8815 HOT MIX HEIGHTS
 LOT 2 BARBARICK SUB.
 COLORADO SPRINGS, CO 80911
 EL PASO COUNTY

ALTERNATIVE LANDSCAPE PLAN

JOB NUMBER	965-20
REVISIONS	
ORIGINAL DATE	12-22-20
DRAWN BY	JM
DESCRIPTION	LANDSCAPE PLAN
SHEET NO.	L1.1

Landscape Plan_V1.pdf Markup Summary

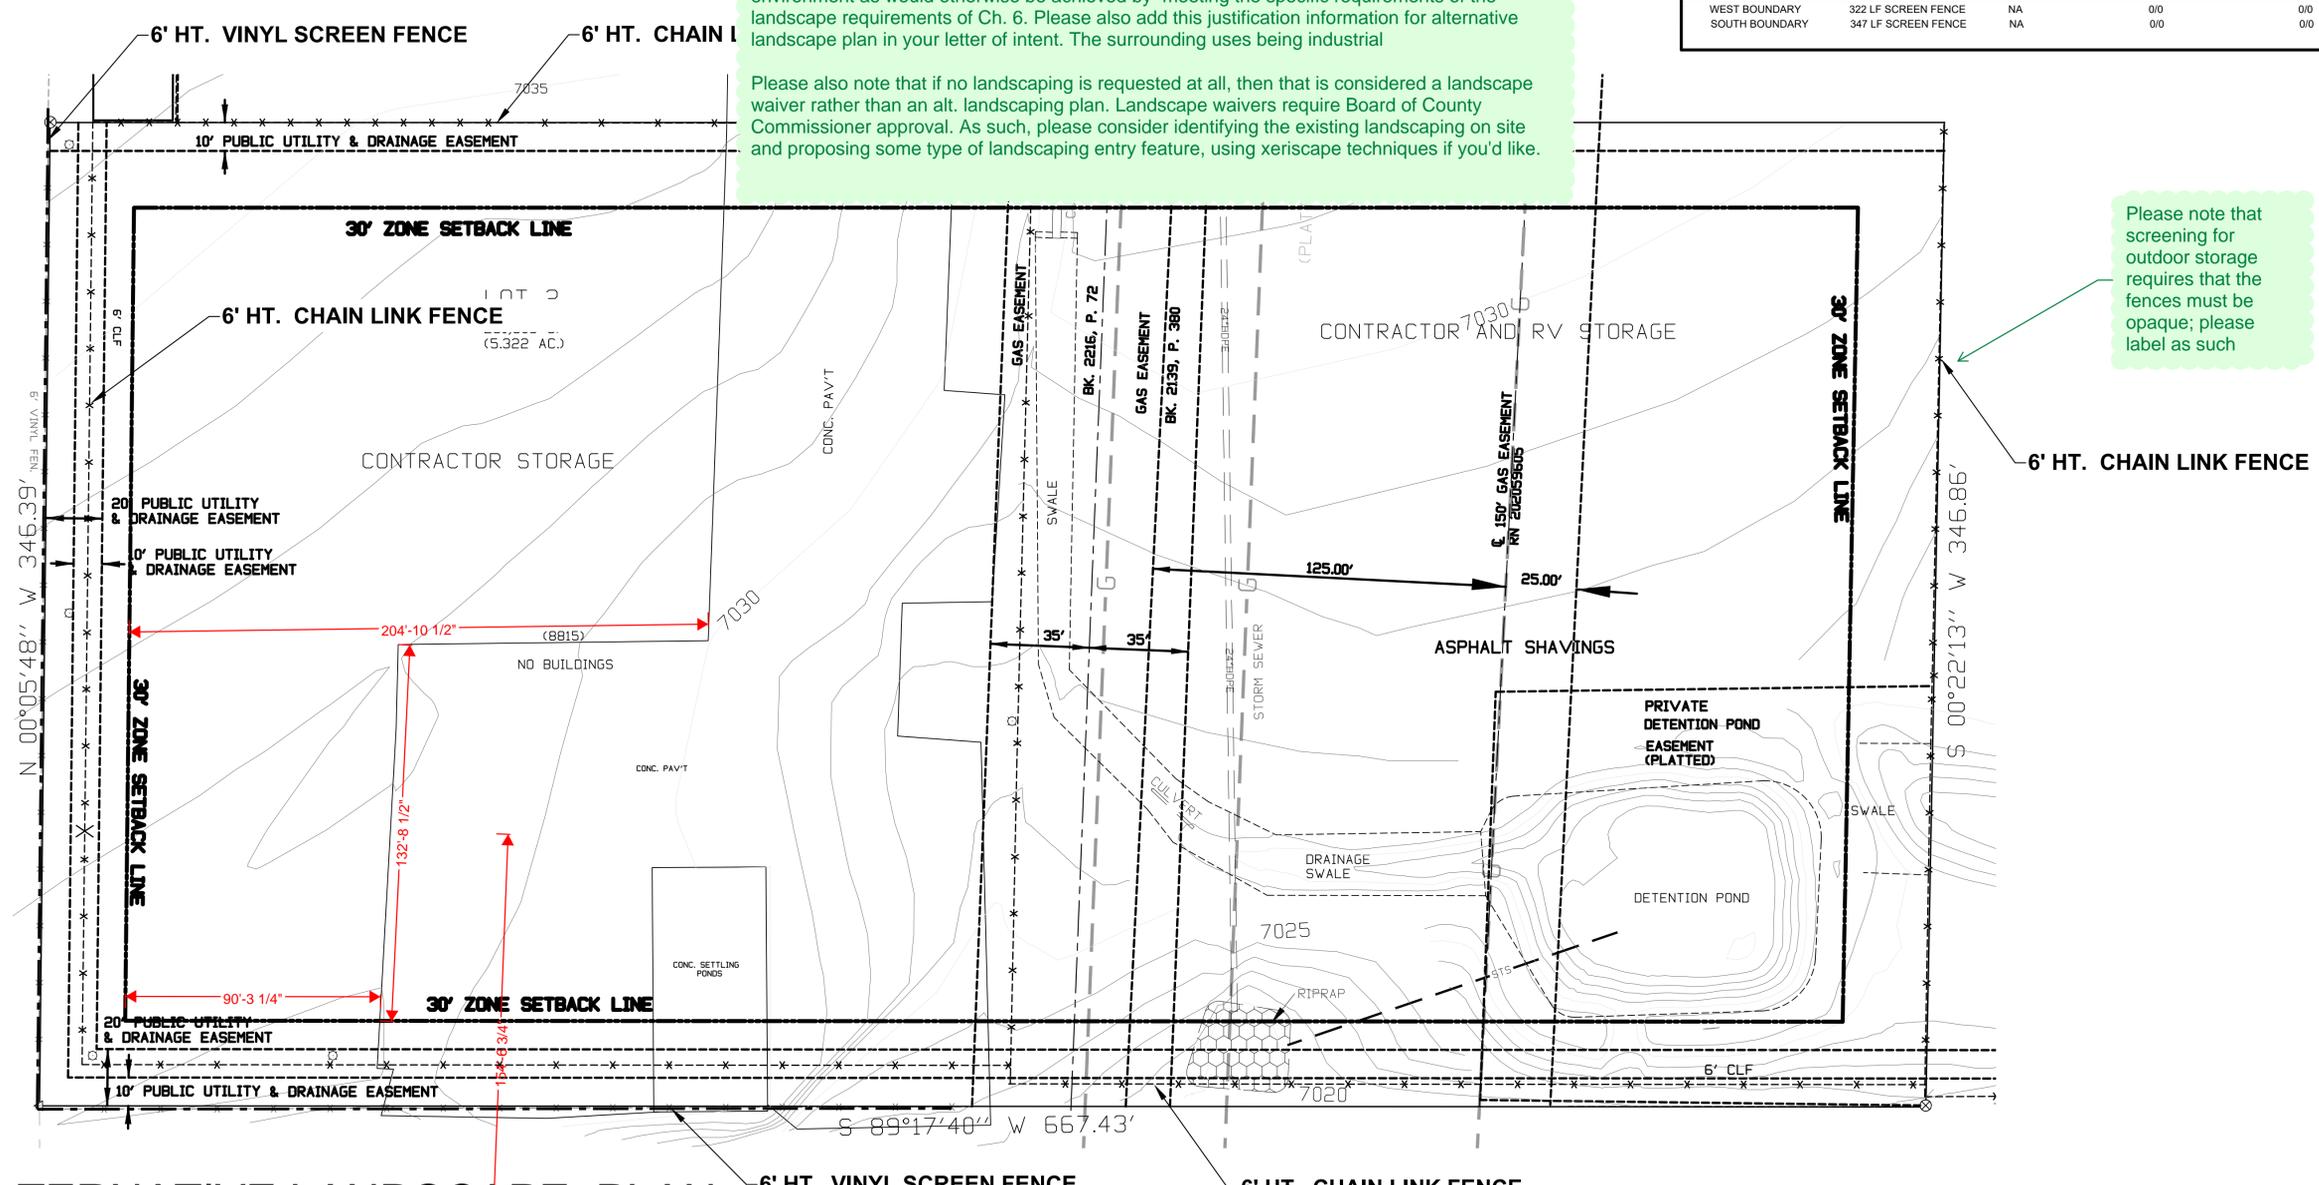
Please note that the landscaping standards required per Chapter 6 for all land uses are different from the intent/requirements of landscape buffering standards for adjacent uses (for outdoor storage requirements per Ch.5).

Please also note that the authority for the Director to approve an alternative landscape plan shall not allow for the Director to eliminate the requirement for landscaping or to diminish the total landscape area required by the landscape requirements in Ch. 6.

Please add landscaping to the site and/or adequately justify how the alternative landscaping plan meets the purpose of the code and promotes the concepts contained in the Landscape and Water Conservation Manual, and provides an equivalent benefit to the community and environment as would otherwise be achieved by meeting the specific requirements of the landscape requirements of Ch. 6. Please also add this justification information for alternative landscape plan in your letter of intent. The surrounding uses being industrial

Please also note that if no landscaping is requested at all, then that is considered a landscape waiver rather than an alt. landscaping plan. Landscape waivers require Board of County Commissioner approval. As such, please consider identifying the existing landscaping on site and proposing some type of landscaping entry feature, using xeriscape techniques if you'd like.

Please note that screening for outdoor storage requires that the fences must be opaque; please label as such
